CITY OF PORTLAND, MAINE

Project Name: 101 York Street Mixed Use Development
Project ID: 2015-139
Address: 85-101 York Street CBLs: 40-C-3, 4, 5, 9, 18, 22, 25, 33
Applicant: 101 York Street, LLC
Planner: Nell Donaldson

PLANNING BOARD REPORT PORTLAND, MAINE

101 York Street Mixed Use Development
85-101 York Street
Level III Site Plan and Subdivision Review
2015-139
101 York Street, LLC

Figure 6: Approximate areas of increased setback on York Street

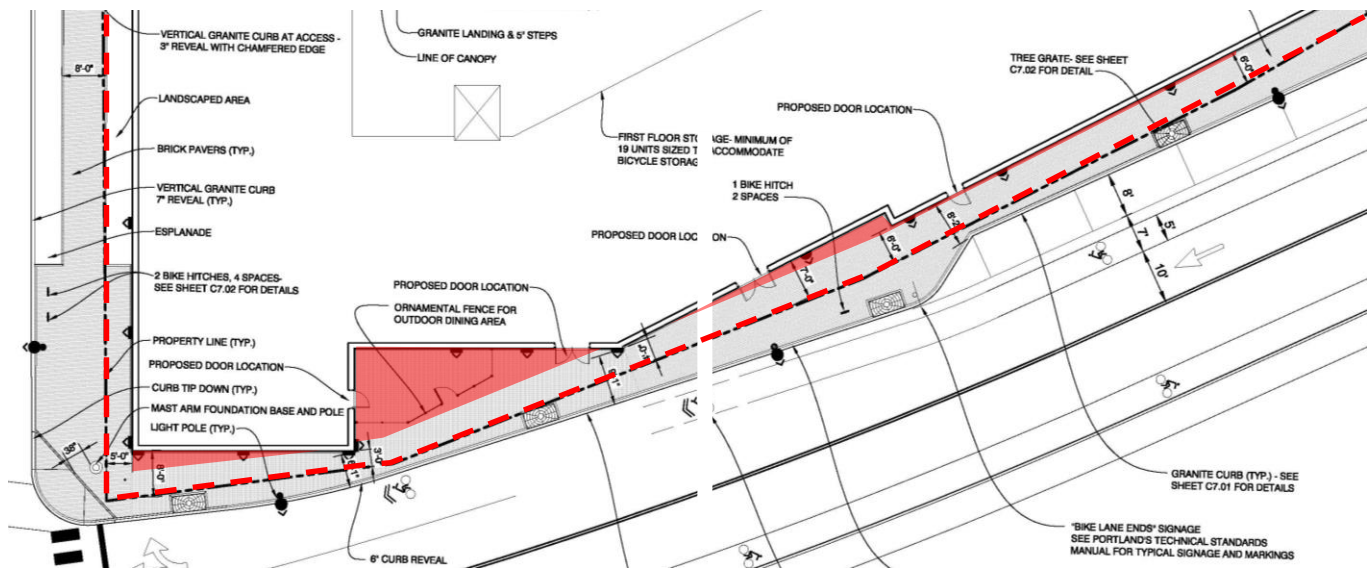
In the final plans, the building continues to exceed the B-3 zone's maximum front yard setback of five feet in several locations. The plans show the point of greatest building setback on the York Street frontage at just over 21 feet (*Figure 6*). In their preliminary submittal, the applicant argued that these setbacks are necessary because of the "unusual geometry of the right-of-way line along the frontage" (*Attachment G*). The applicant has also stated that the increased setbacks will "provide pleasant sidewalk widths while accommodating east-west bike lanes, east-west sidewalks and on-street parking" and provide an "opportunity to support open space amenities such as building entries, outdoor seating, street trees, bike racks, and municipal lighting" (*Attachment U*).

In the case of the present development, the increased setbacks provide some relief for what will be a fairly narrow sidewalk in several locations. The applicant has worked with staff to arrive at a York street cross-section which accommodates vehicles, bicycles, and some on-street parking. The result is a curb line which falls fairly close to the property line in a number of areas. In order to provide sidewalks of significant enough width to create a comfortable pedestrian experience, extended setbacks are desirable.

However, it should also be noted that the final plans have removed some pedestrian level details, most notably the sidewalk seat wall and planters, which in the preliminary plans enhanced the streetscape in these areas of increased setback. Staff’s urban design review has questioned the removal of the seating wall (*Attachment 1*). Further, the design review states that “the ornamental fence around [portions of] the proposed additional setback...removes public access to the widened sidewalk. Planning staff recommends a finding that the increased setback provides substantial and viable publicly accessible open space, does not detract from the street wall character, does not create an excessive amount of open space, and provides areas of high quality and character of design, subject to the applicant finalizing the design of the areas of increased setback for review and approval by the city’s urban designer.

The Planning Board approved the additional setback per *Section 14-220(c)* on the condition that the applicant shall provide revised plans including amenities and insuring public access in areas of increased setback for review and approval by the city's urban designer prior to the issuance of a building permit.
